## BUILDING PERMIT

has permission to Change of Use; from 3 family to 4 family dwelling

Re: McMann Residence  
76 Morning Street  
Portland, Maine

McMANN RESIDENCE

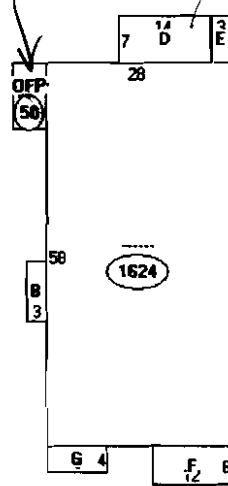
3/11/2010-mes: Spoke to owner - there are new decks that go beyond the footprint the the existing building. I can not complete my

zoning until I get a site plan - He said he would bring in a site plan soon - MES

3/15/2010-mes: Harry dropped off scalable site plan - It doesn't show the new projecting deck on the 3rd floor - I am concerned about lot coverage and the deck setbacks. The owner is to come in this afternoon to bring a new plan and to discuss concerns.

3/15/10 - still not showing  
The 3<sup>rd</sup> floor New deck -

3/24/10 - revised information from  
DAVID MATERO

3/24/2010-mes: received e-mail information from David Matero that confirms the lot coverage and compliance with zoning.

REVISED FOUNDATION PARTIAL PLAN

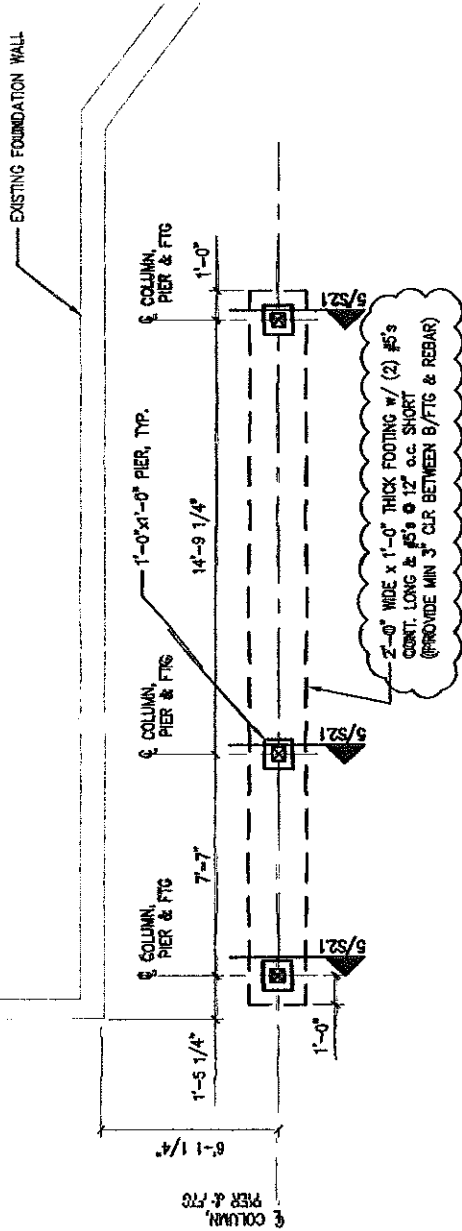
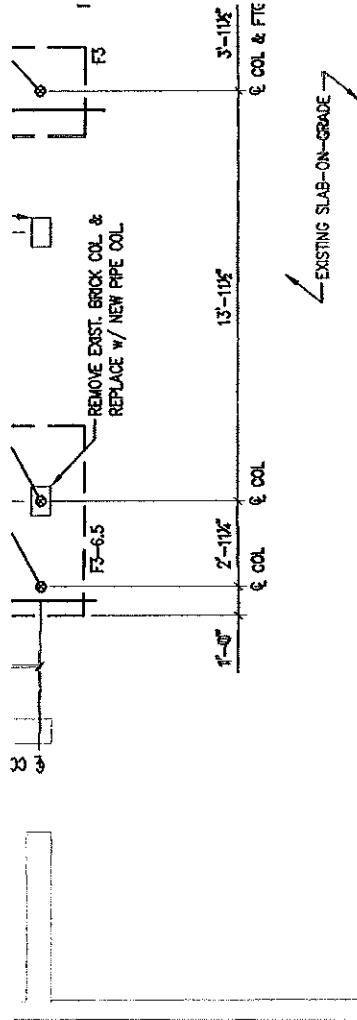
12-8-10 DWM Footings @ Moody st under new decks OK  
contact Fdn Mike Foreman Larry Contractor Harry.

12-15-10 DWM OK to Backfill

3-7-11 DWM Larry 232-8613 Provide 1hr protection  
between 2 units, provide revised plan, Provide blocking  
at floor joists, repair cut joist in basement.

3-9-11 DWM Larry, Harry Corrections made except new  
revised plans are not as built. Structural engineer to  
renew job & issue a letter stating that the construction  
is as per plan & conforms to code.
